#### SUNDRY NOTICES AND REPORTS ON WELLS

1. Type of Well				NMnm-119229		
Oil Well 🕢 Gas			8. Wel	Name and No. R	HINESTONE 29 FED COM #1	
2. Name of Operator RUBICON OIL & GAS, LLC (194266)				9. API Well No. 30-005-63936		
3a. Address 508 W. WALL ST., STE. 500, MIDLAND, TX 79701 3b. Phone No. (include area code) 432-684-6881				10. Field and Pool or Exploratory Area DIAMOND MOUND; MORROW 76079

#### Rhinestone 29 Fed Com 1 30-005-63936 Rubicon Oil & Gas November 1, 2019 Conditions of Approval

### Permanent Abandonment of Production Zone Conditions of Approval

**Proposed P&A Wellbore** API No. 30-005-63936

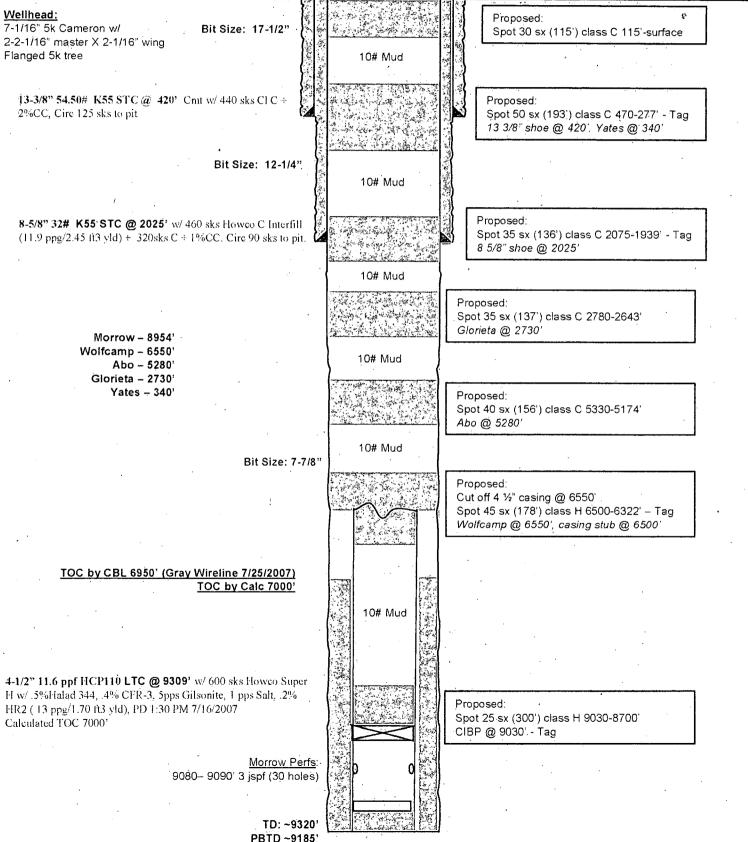
1. Operator shall place CIBP at 9,030' (50'-100' above top most perf) and place 25 sx of Class H cement on top as proposed. WOC and TAG.

Note: If operator not does successfully pull the 4-1/2" casing out of hole from 6550 to surface the following plugs will all be perf and squeeze plugs with WOC and TAG.

- 2. Operator shall place a balanced Class C cement plug from 6,500'-6,322' as proposed to seal the Wolfcamp Formation.
- 3. Operator shall place a balanced Class C cement plug from 5,330'-5,174' as proposed to seal the Abo Formation.
- 4. Operator shall place a balanced Class C cement plug from 2,780'-2,643' as proposed to seal the Glorieta Formation.
- 5. Operator shall place a balanced Class C cement plug from 2,075'-1,939' as proposed to seal the 8-5/8'' shoe. WOC and TAG.
- 6. Operator shall place a balanced Class C cement plug from 470'-250' as proposed to seal the 13-3/8" shoe, Yates Formation, and bottom of the Salt. WOC and TAG.
- 7. Operator shall place a balanced Class C cement plug from 150'-surface as proposed to seal the top of Salt.
- 8. See Attached for general plugging stipulations.
